DESCRIPTION

DATA SHEET REVISION SUMMARY

The following represent the key differences between 12/16/96 and 06/12/97 version of the DS1314 data sheet. Please review this summary carefully.

FUNCTIONAL BLOCK DIAGRAM Figure 1

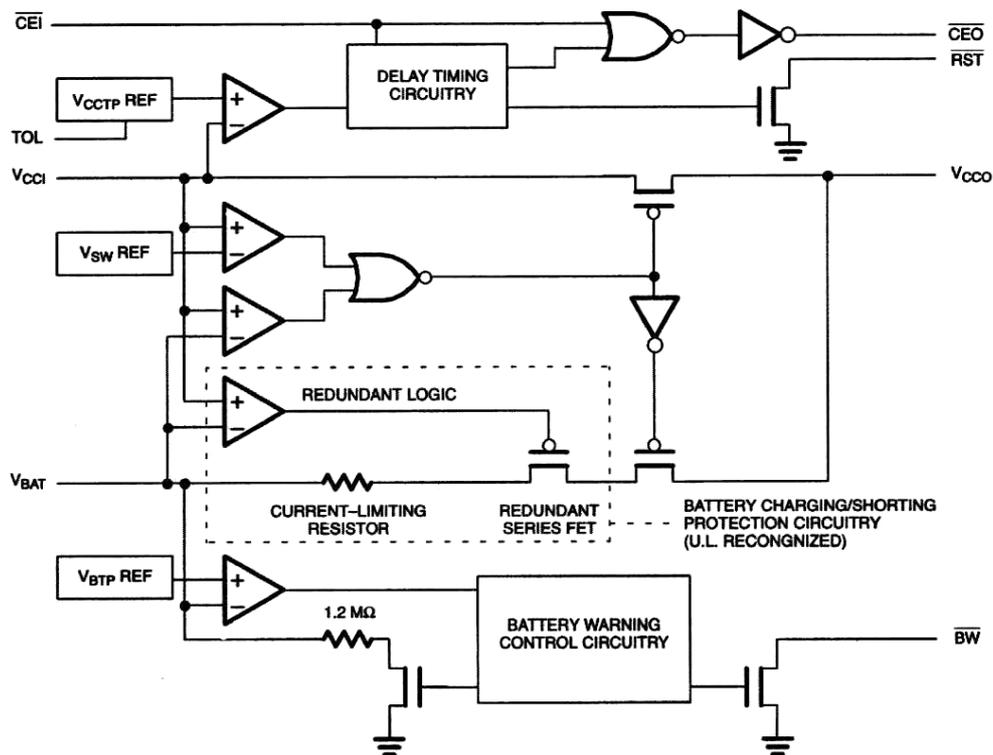
1. Changed V_{BAT} max to 6V.
2. Changed V_{CCTP} values to 2.8-3.0V (TOL=GND) and 2.5-2.7V (TOL= V_{CC}).
3. Changed t_{BABW} from 7s to 1s max.
4. Changed block diagram to show U L compliance.

OUTPUT LOAD Figure 2

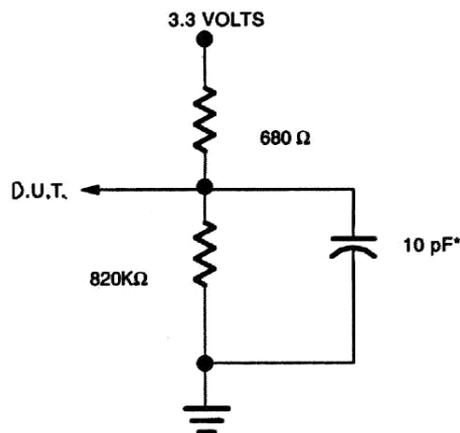
1. Changed AC test conditions.
2. Changed t_{PD} to 20 max & 12typ.
